VESSEL'S NAME S.S. S. Derwent Rpt. By No. 9744

Nature of Survey _____ 2nd S.S. No. 3.

THICKNESSES OF PLATING ascertained by drilling, and comparison of same with the original thicknesses.

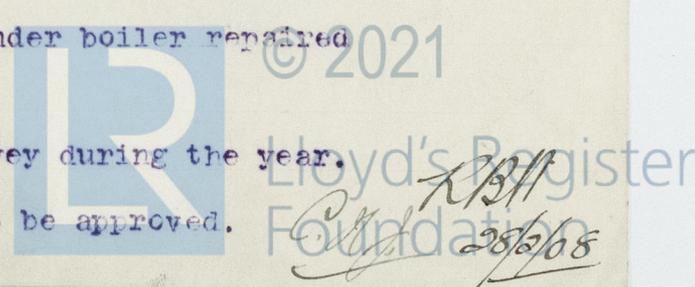
The 2nd S.S.No.3, due 1,08, has now been partly held and the plating drilled with results as shewn above. The Surveyors have been communicated with regarding the diminution in the thickness of the 1st strake below the sheerstrake forward and they state in reply that they did not consider it necessary for any repairs to be effected or compensation made on account of the excess in the thickness of the strake above.

To complete the survey the whole of the ceiling requires to be lifted in the holds and bunkers, and these spaces to be examined, the double bottom tanks to be examined internally and tested, the cables to be ranged, the pumps and sluices to be examined and 8 plates on the port side to be removed, faired and replaced and also two on the starboard side and one plate in A strake under the boiler to be renewed.
